Report to Planning and Environment Committee

Subject: 1423197 Ontario Inc. (Royal Premier Homes)
307 Fanshawe Park Road East

Public Participation Meeting on: July 15, 2020

Elevations – Building B

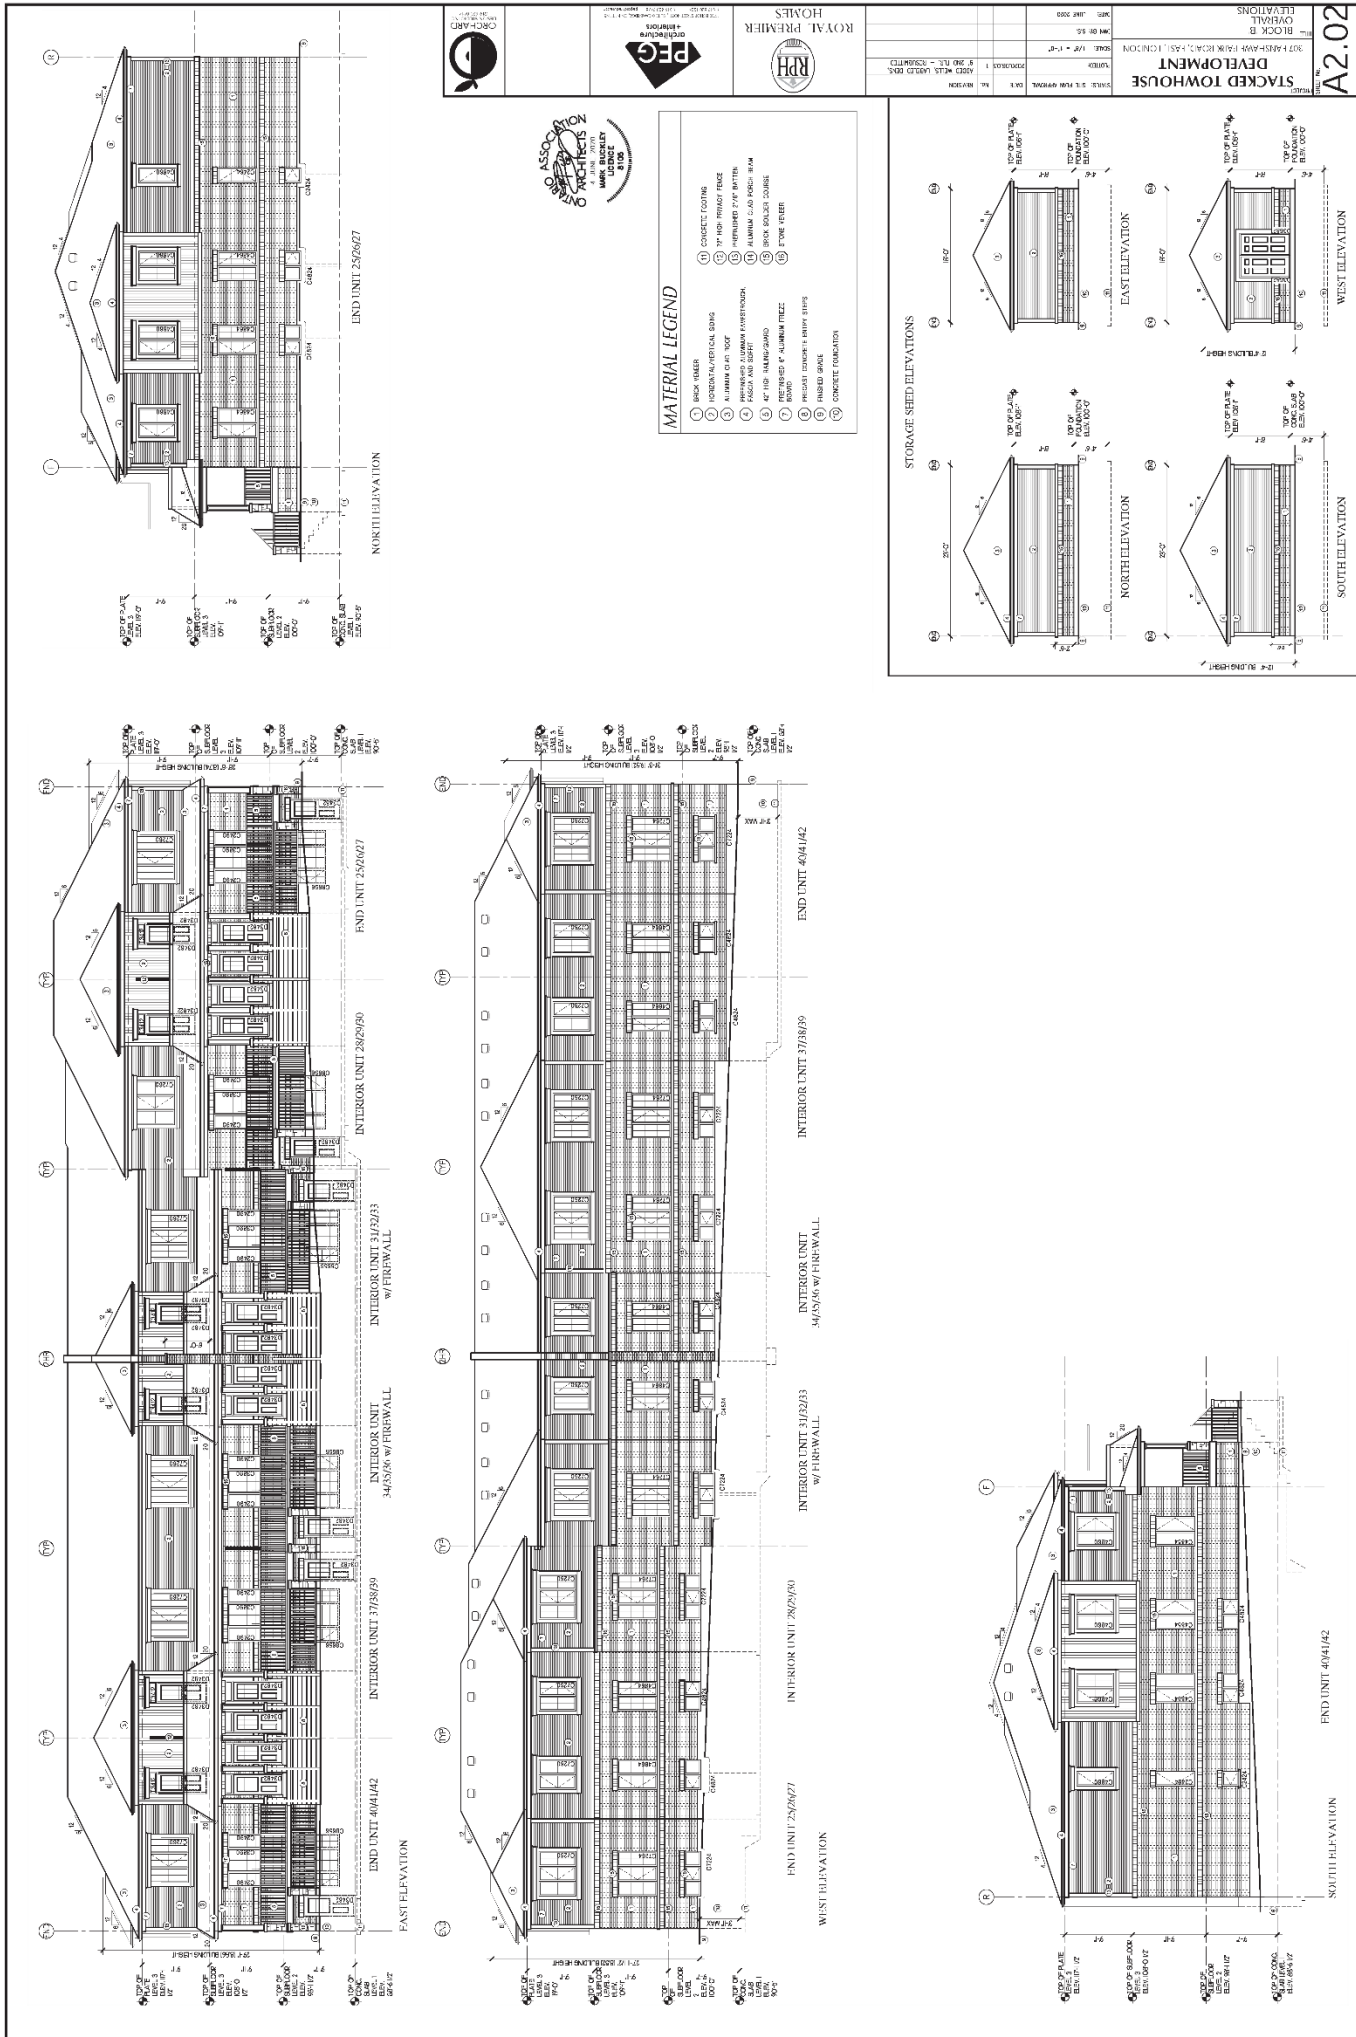
- The west elevation of Building 2 requires further articulation in order to provide better compatibility between it and the neighbouring residential neighbourhood.

- The wood siding on the exterior does not add to the articulation of the building and does not seem to relate to any contextual elements. The exterior design does not offer the depth of detail or articulation expected for a development in a neighbourhood this well developed, with a long history, and on arterial road.

- in the current proposal, the 3rd floor west windows of the building fronting Fanshawe are now full windows looking over the neighbouring properties. In the earlier plan, the developer had met privacy considerations by opting for transom windows on that side of the building. There is no good reason to go back on that decision, especially since both PEC and City Council passed this part of the plan and were satisfied that the privacy of neighbouring properties was respected;

3. The transom-style windows on the western end of the northern (taller) block of buildings have been replaced with full length windows. The former had been offered as a means to minimize loss of privacy for neighbors on the north western border. Why has this changed? If parking and residence numbers are diminished, please ask that the upper two stories of the northern residential block be staggered back from the Western boundary, and that no large balconies replace them;
